LiDAR Quality Assessment Report

KS_Area1-Eastern_2013

NGTOC
2014-06-30

The project Area 1 Kansas includes Anderson, Allen, Neosho, and Labette counties. Areas were defined and supplied by Kansas Department of Administration and includes approximately 2250 square miles for analysis.

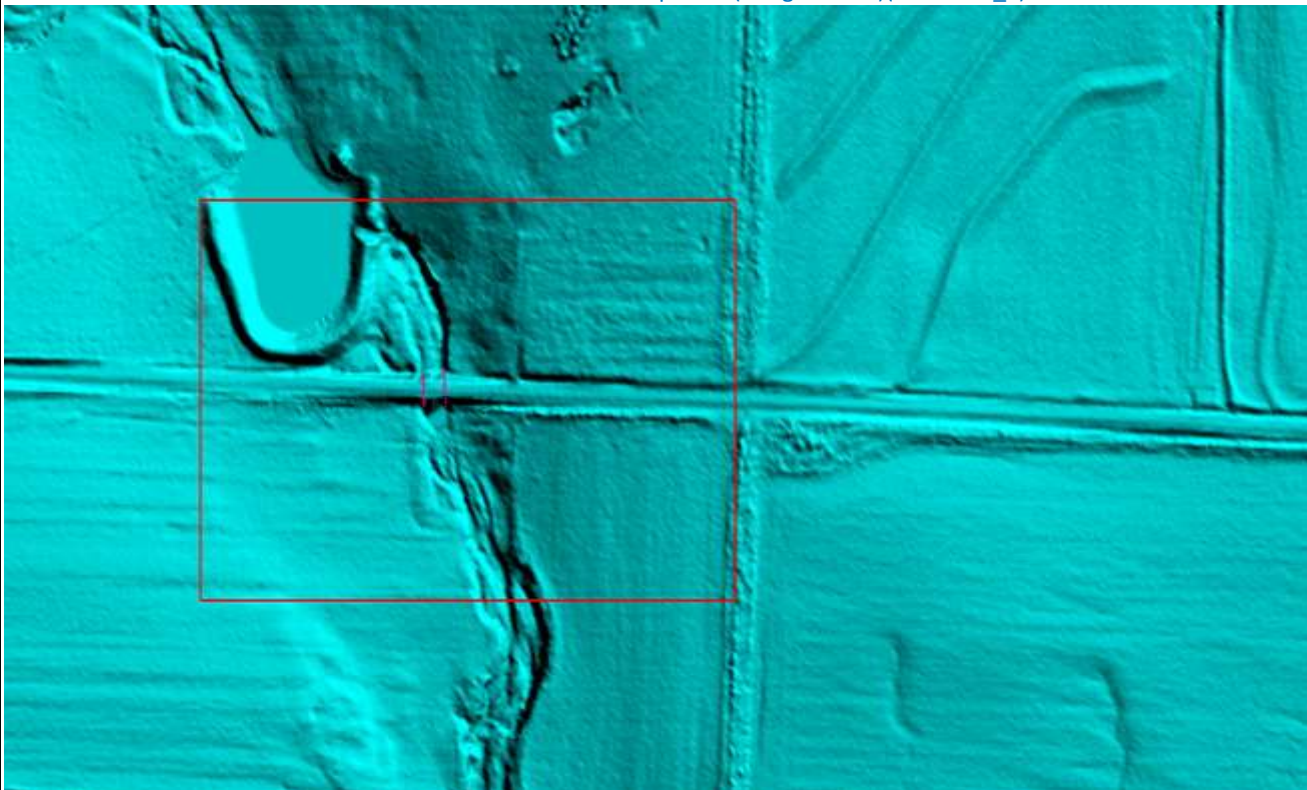
- During QA review, reviewer noted that some rivers in the DEM have been hydro-flattened that appear to be under fifty feet bank to bank, while others have not. Please review/comment. [Corrected by vendor.](#)
- Breaklines shapefile appears to be incomplete as some hydro-flattened water features are missing breaklines. Re-delivery of breakline file needed. [Corrected by vendor.](#)
- Some bridges and culverts had breaklines while others did not (as shown below). Please comment. [This problem still exists in some locations.](#) [corrected by vendor](#)

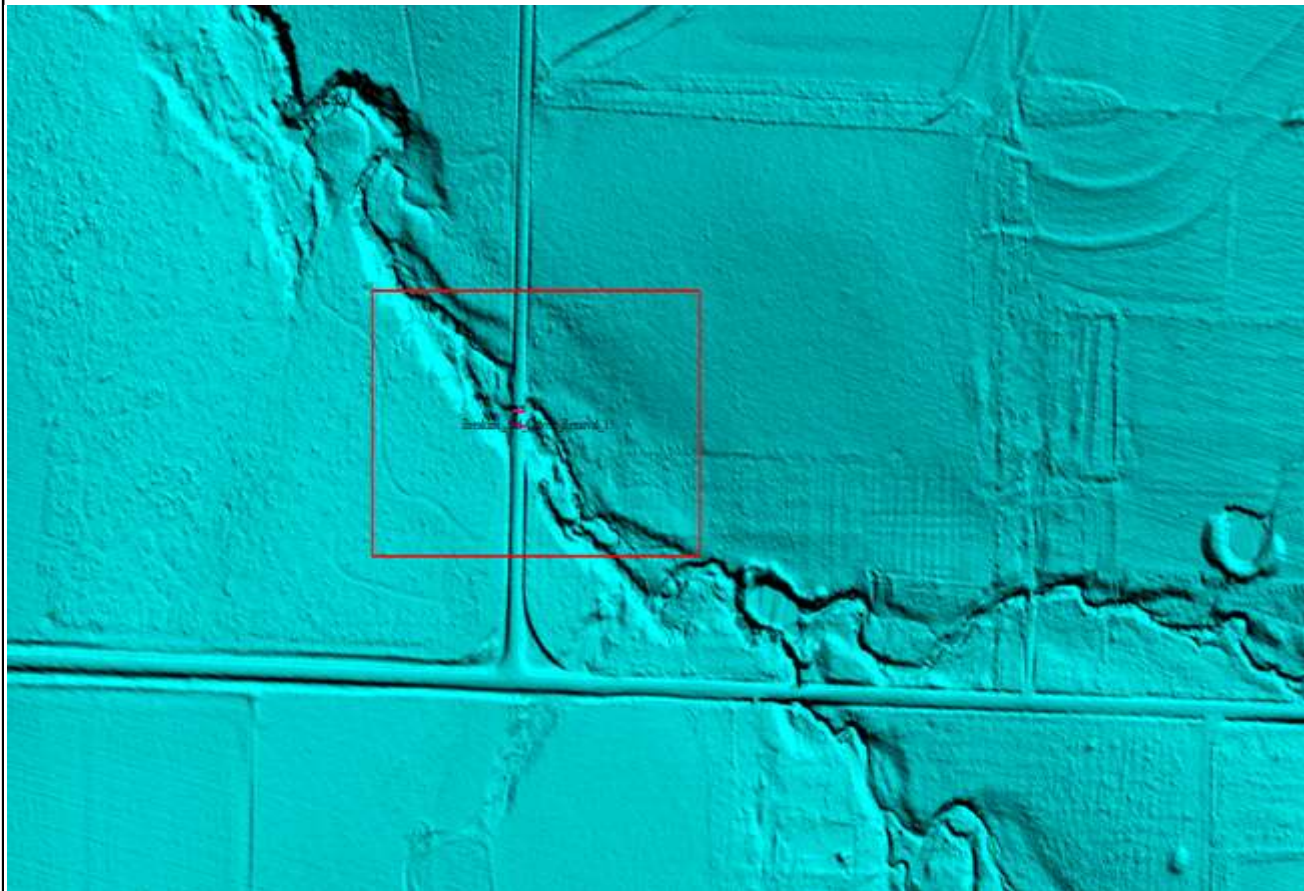
*****some breaklines still exist where culverts have been replaced (image below)(Breakline_1)

*****some culverts have been partially removed and breaklines remain. (image below) (Breakline_and_Culvert_1)

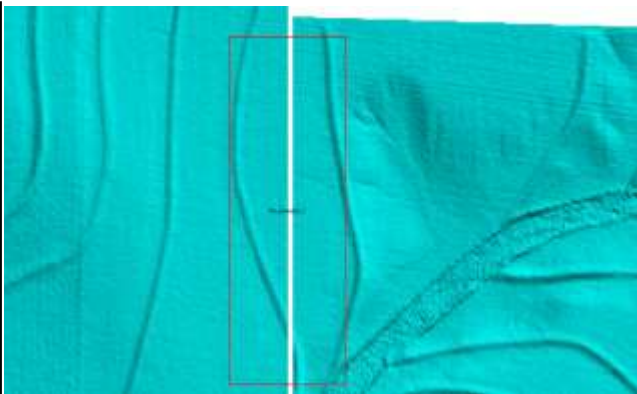
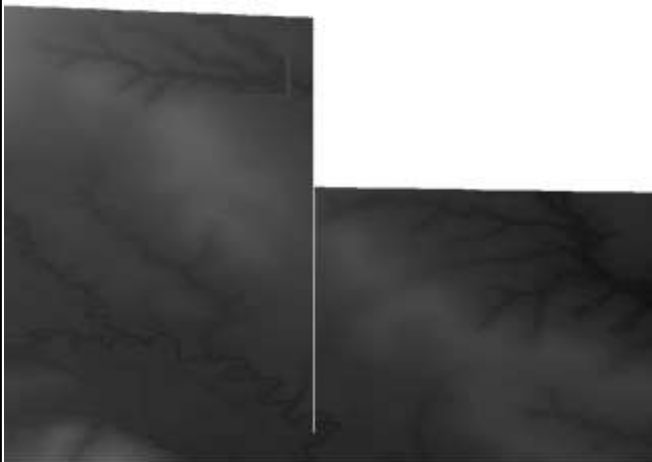
Image from Global Mapper showing tile mismatch (above) and ArcMap (below). [Corrected by vendor.](#)

Tile mismatch between DEM tiles BE_15STC8550 and BE_15STC9050. [Corrected by vendor.](#)

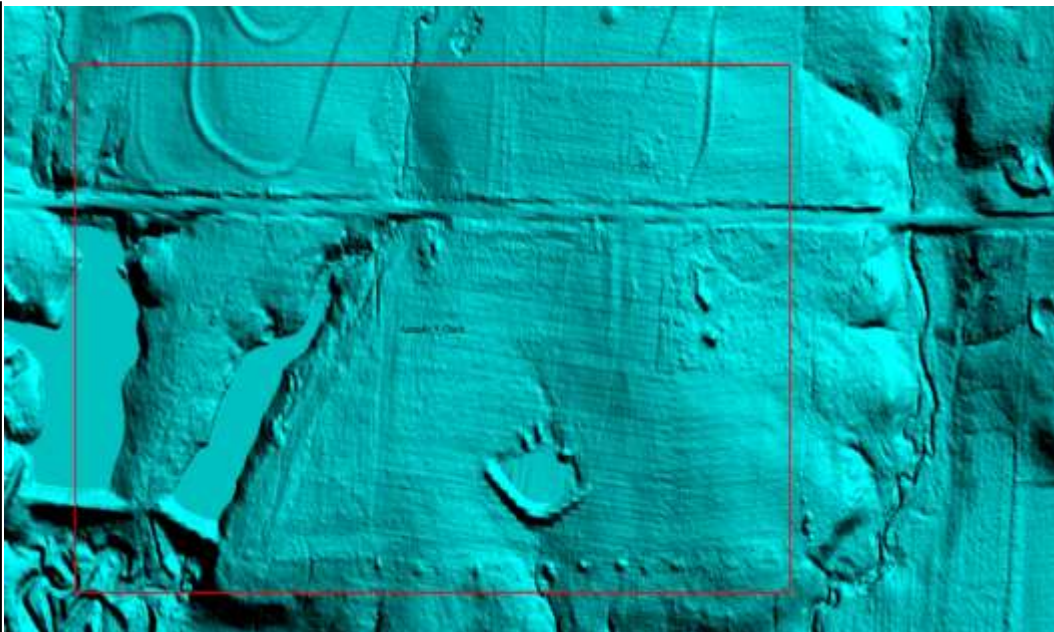
****Boundary shapefile does not conform to data extent (just follows the boundary of the tile extent)

[Corrected by vendor](#)

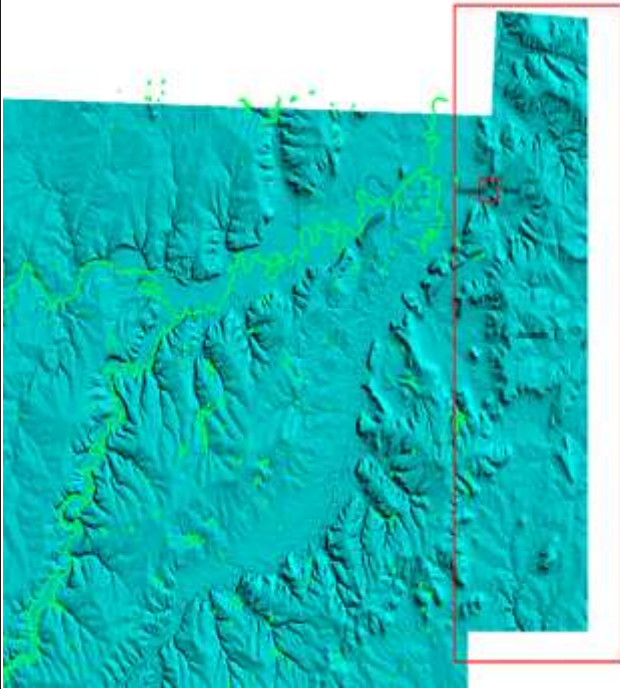
Anomalous error (Anomaly_9) showing different data resolution. Location: 37° 34' 18.9748" N, 95° 06' 11.3445" W
*****Not corrected, but accepted

Global Mapper error image (above) ArcMap image
*****This errors still exist. It seems to be endemic throughout the north-eastern corner of the dataset. Please
recheck (see new error images below and in error shapefile). Accepted, See explanation from vendor below.

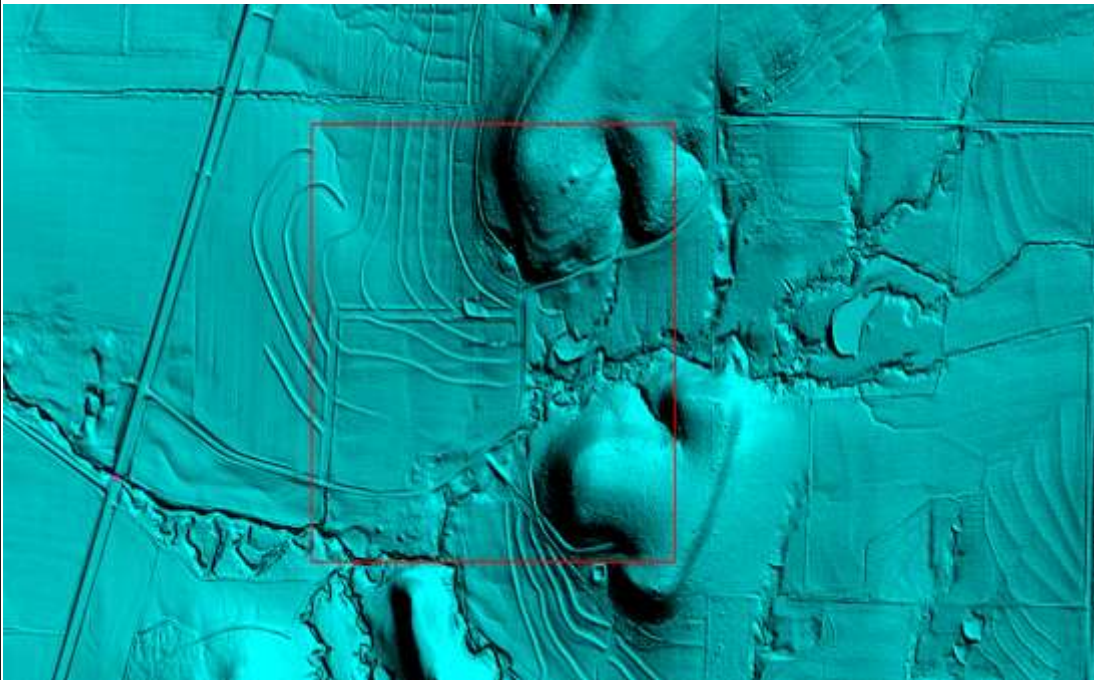
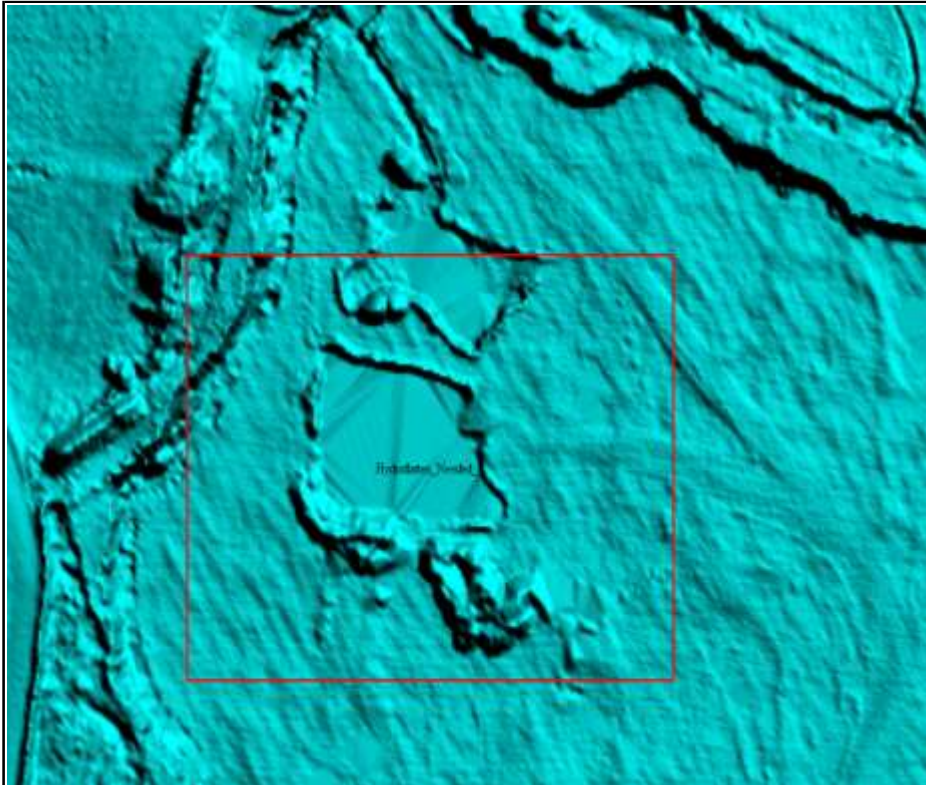
Error identified along entire eastern edge of DEM. Location: 37° 57' 1.2367" N, 95° 07' 50.7476" W *****Not corrected

"In the UTM15 geodatabase a shape has been added with the description of *Kansas_2012_Data_Limit*. In order to provide full tile DEMs between Kansas 2013 and Kansas 2012 project areas, Kansas 2012 data was included. The inclusion of Kansas 2012 data introduced a visible seam between the two data sets due to seasonal changes, differences between missions, and sensors. The only way to alleviate the appearance of the anomalous error would be by the removal of the Kansas 2012 data, and by providing partial tiles along the eastern boundary of Kansas 2013."

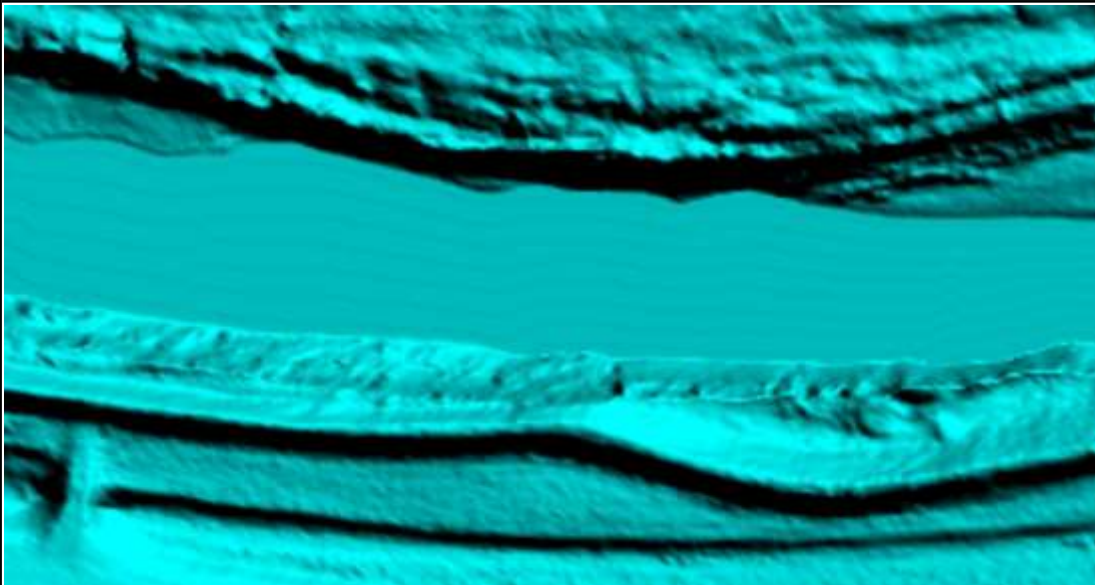
Hydro-flattening error (Hydroflatten_Needed_5). Location: 37° 45' 54.2384" N, 95° 26' 20.3021" W. Three similar errors exist. *****Corrected by vendor

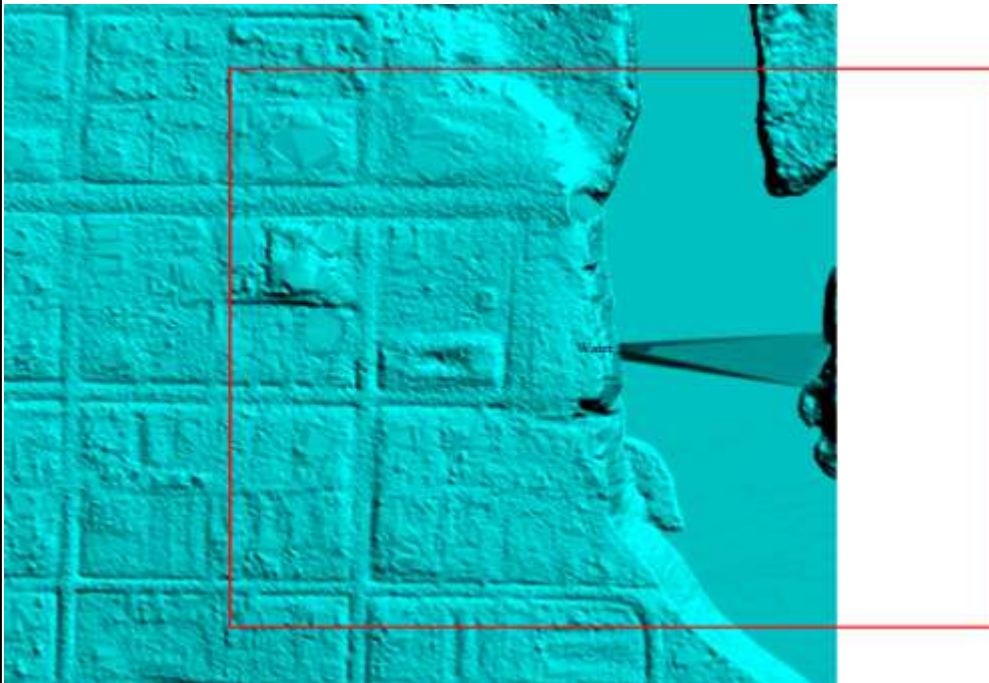
Several hydro-flattening errors exist within the streams. Image above is representative (Water_Issue_11). 15 of these error types exist; please review river system where errors exist.

***River errors corrected by vendor

***Water issue beneath bridge. Corrected by vendor.

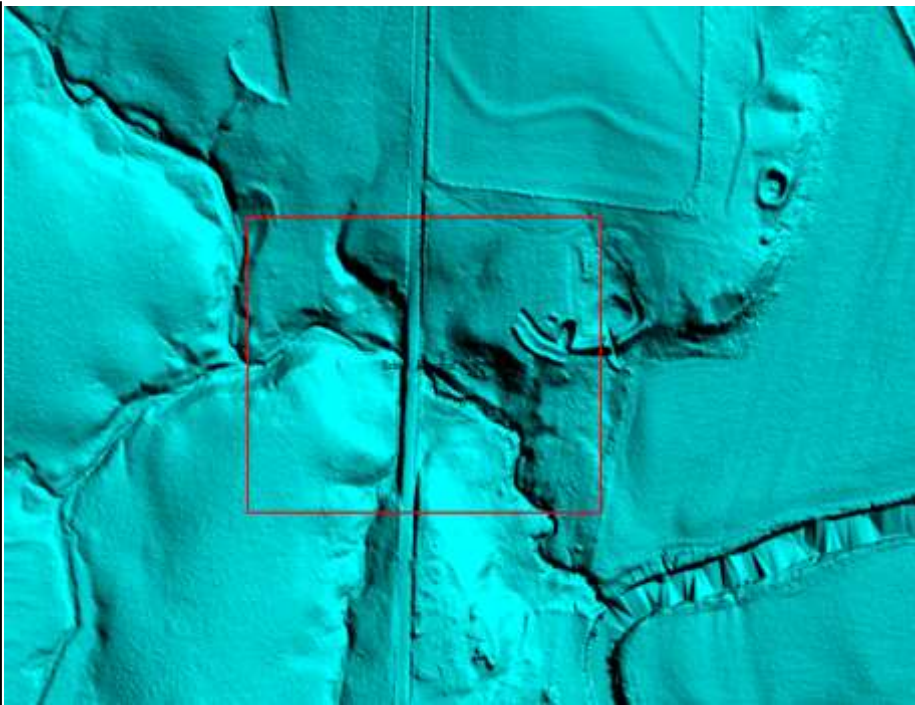
Several errors exist where bridges were not removed from DEM. Above image is representative (Bridge_Removal_6). Location: 37° 34' 39.3071" N, 95° 08' 34.2986" W***Corrected by vendor

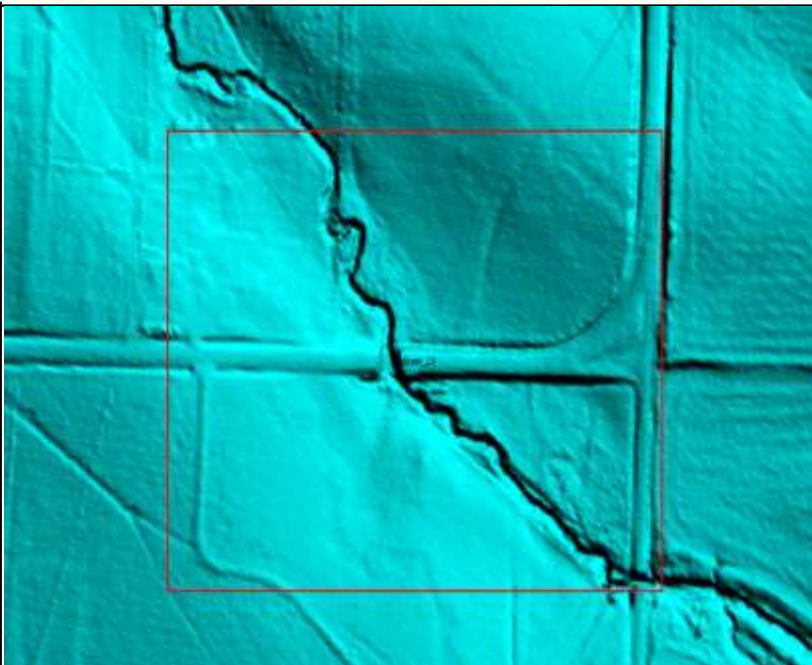
Culvert errors in which culverts were removed from DEM and need to be added back in. Above image is representative (Culvert_29) Location: 37° 52' 41.9722" N, 95° 25' 45.0572" W. 97 of this error type exist. ***Corrected by vendor

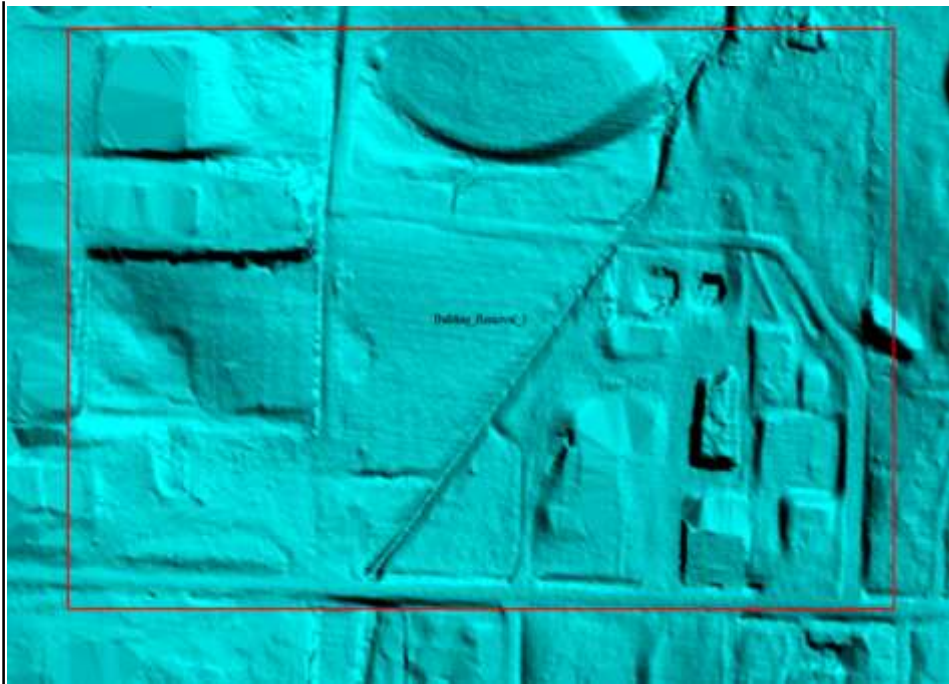
Buildings not removed from DEM. The above image is representative of this error type (Building_Removal_1). Location: 38° 17' 21.8901" N, 95° 14' 43.5772" W. 4 of this error type exist. [****OK, thanks for info.](#)
